CITY OF BIDDEFORD

STAFF REVIEW COMMITTEE REPORT

RE: **2020.14 Site Plan Review for James Godbout to construct a 5,000 square foot storage building and associated site infrastructure at 486 Elm Street (Tax Map 18, Lot 29) in the B-2 Zone.**

SHEET
1

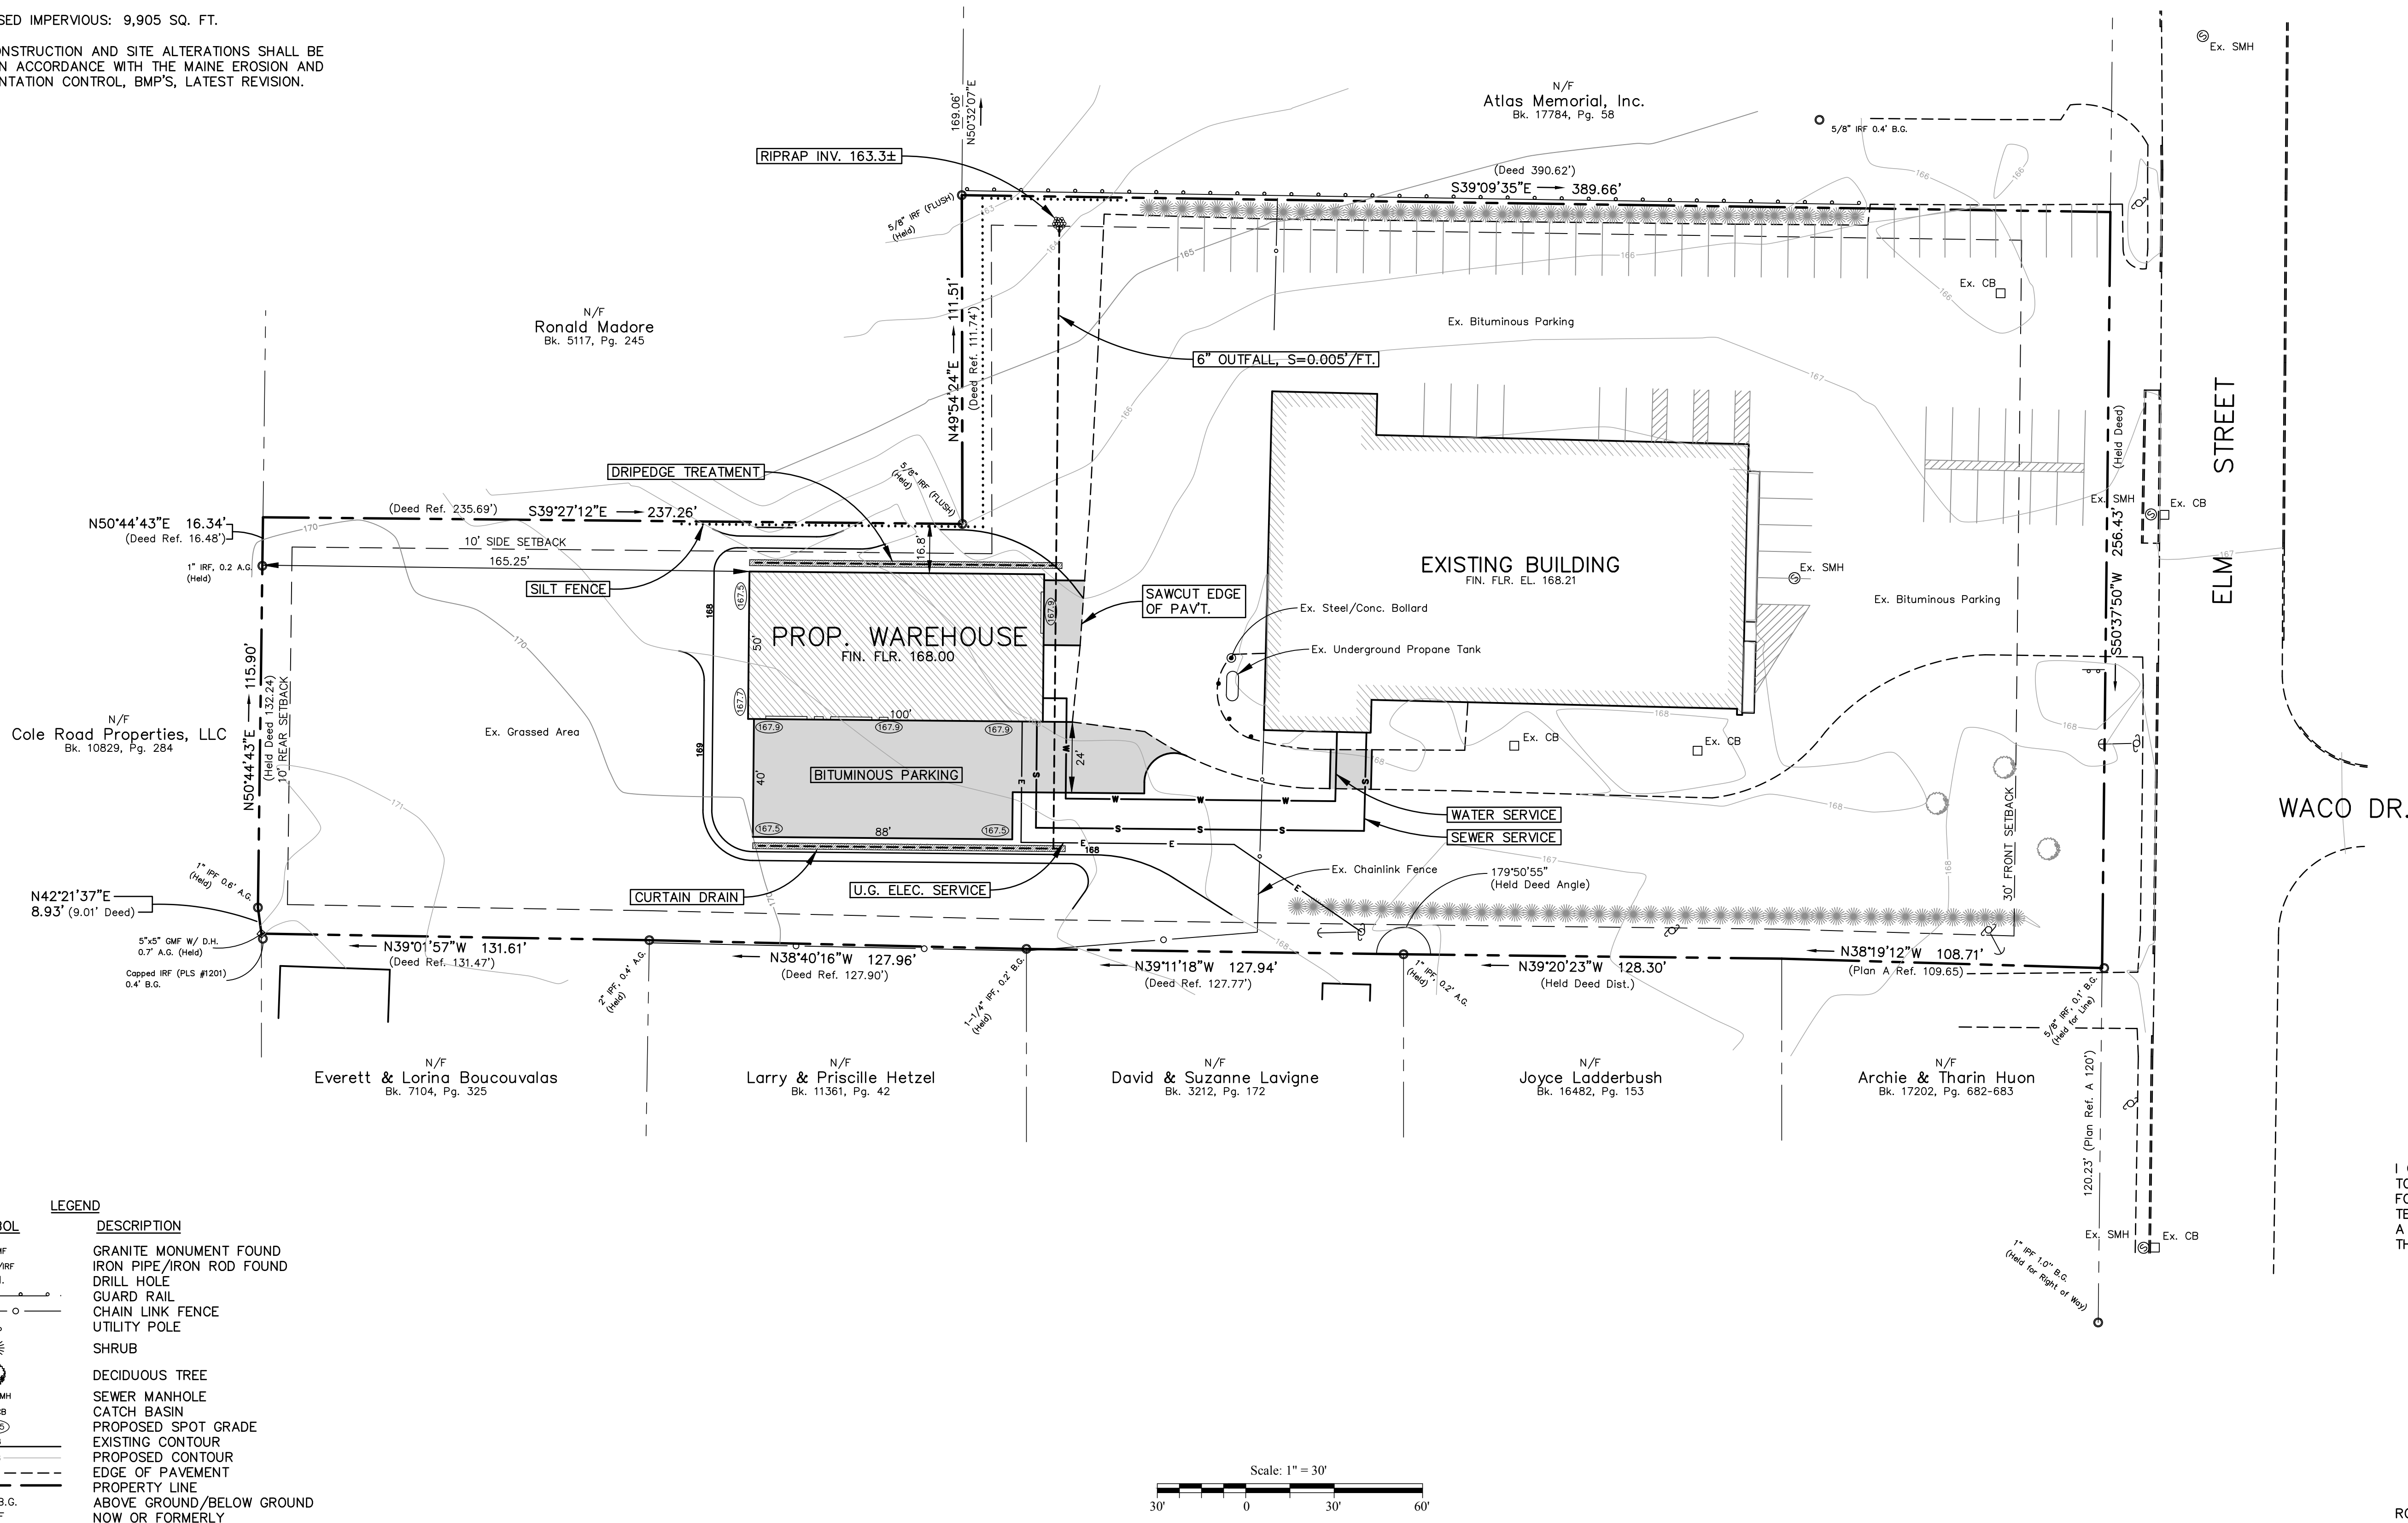
9. Art. XI, Sec. 5.A.(4): Plan Sheet 1 – Add North Arrow
10. Art. XI, Sec. 5.A.(7)(d): Plan Sheet ? – Show *“Outline of any buildings located within 200 feet of such existing or proposed buildings or structures indicating their shape, size, location, heights, and volume.”*

22. Add a Note to Sheet 1 as follows:
